Product / Process Change Notification (PCN)

PCN Number: PCN_UtGDTMID_20240712

Affected Series: MID-GDT

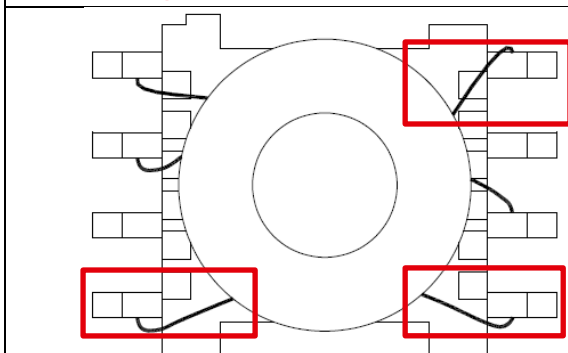
Turns ratio tolerance value will be updated.

Before Change		After Change	
(1-4):(5-8)	1:1, ±1%	(1-4):(5-8)	1:1

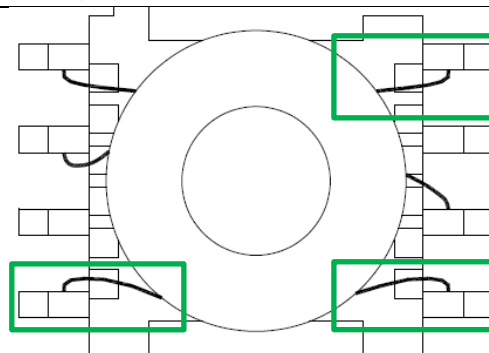
Pin 4, 5, 8 termination direction will be updated.

Before Change

After Change
